## DEVELOPMENT APPLICATION ASSESSMENT REPORT

<b>Application Number:</b>	DA2020/1691
----------------------------	-------------

<b>Responsible Officer:</b>	Thomas Burns
<b>Land to be developed (Address):</b>	Lot 2316 DP 752038, 4 Southern Cross Way ALLAMBIE HEIGHTS NSW 2100
<b>Proposed Development:</b>	Demolition works of existing dwelling and construction of dwelling house, secondary dwelling and studio
<b>Zoning:</b>	Warringah LEP2011 - Land zoned R2 Low Density Residential
<b>Development Permissible:</b>	Yes
<b>Existing Use Rights:</b>	No
<b>Consent Authority:</b>	Northern Beaches Council
<b>Land and Environment Court Action:</b>	No
<b>Owner:</b>	Jaczac Nominees Pty Ltd
<b>Applicant:</b>	Anthony James

**Figure 1:** *Height of the development relative to the natural ground level (measurement highlighted in*

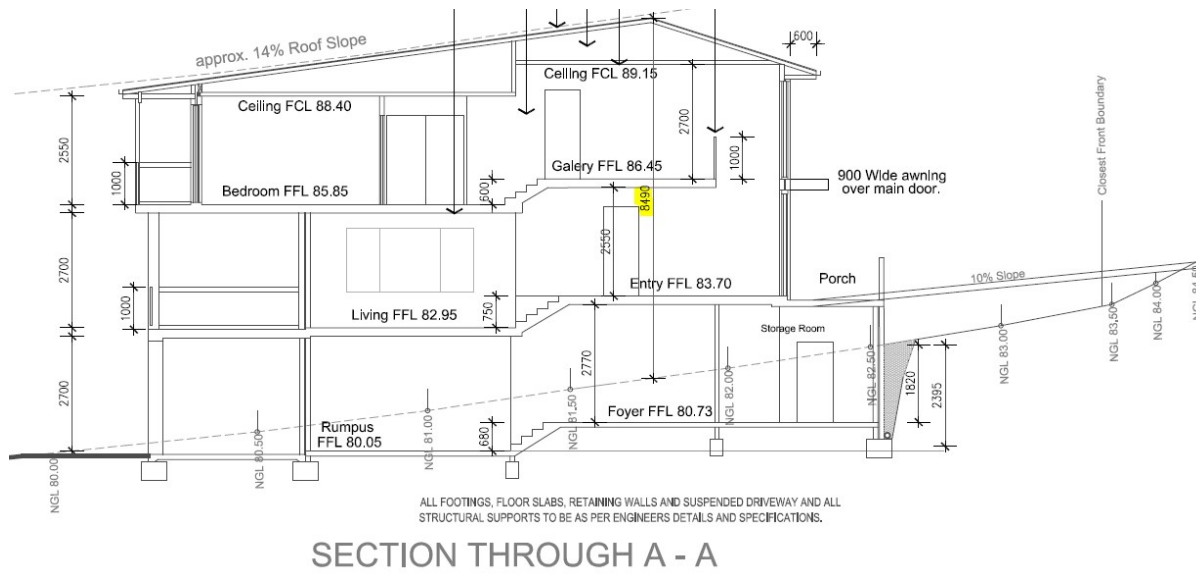
In calculating the height of the dwelling house relative to the natural ground level, the maximum building height is 8.49m, thereby compliant with Clause 4.3 of the WLEP 2011. Figure 1 depicts the structure in relation to the natural ground level.

**Figure 2: available solar access at 9am on June 21**

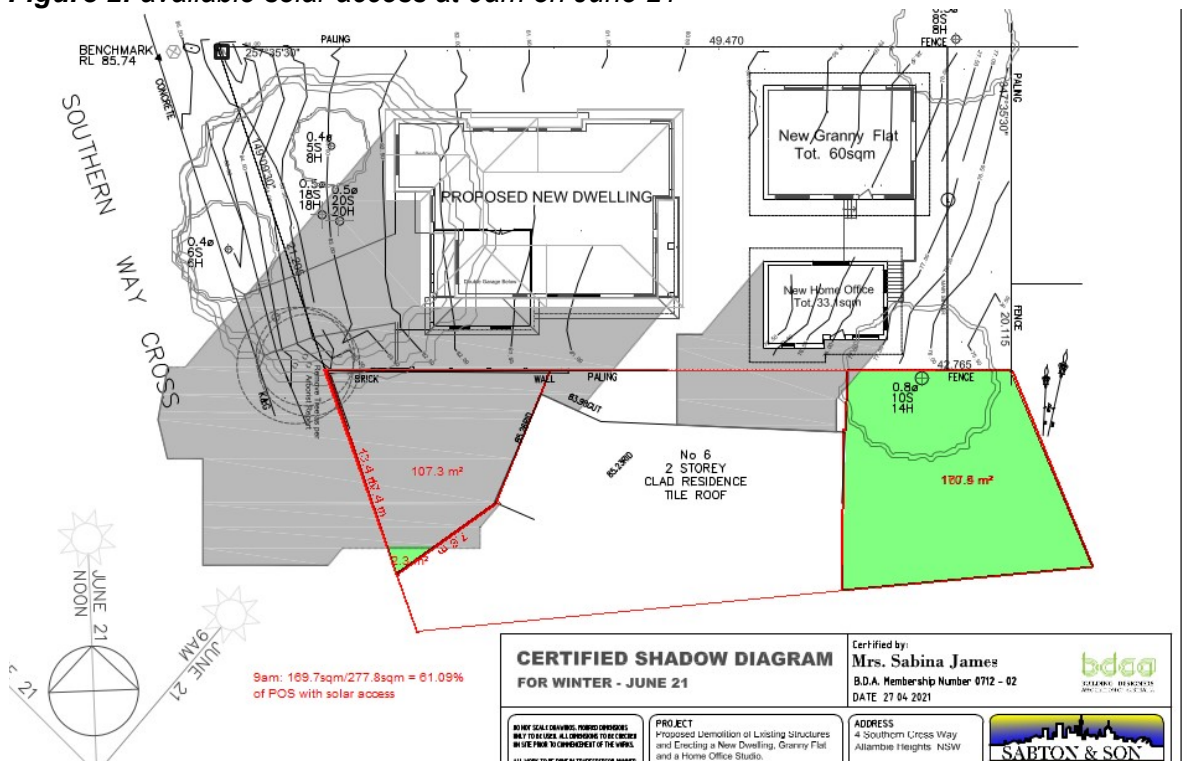
Council's Assessment Officer has utilised available information to extrapolate the outline and configuration of the southern adjacent site (No. 6). The outline of the adjoining private open space has been overlaid on the below shadow diagrams. The areas highlighted in green on the below diagrams represent portions of private open space that receive solar access at 9am, 12pm and 3pm on June 21 (winter solstice).

As demonstrated in the above shadow analysis, the most impacted period of the day is at 3pm on June 21. However, 55.47% of private open space will still receive sunlight during this time. Therefore, the proposed development maintains full compliance with this control between 9am-3pm on June 21.

It is concluded that the proposed development satisfies the requirements and objectives of this control.
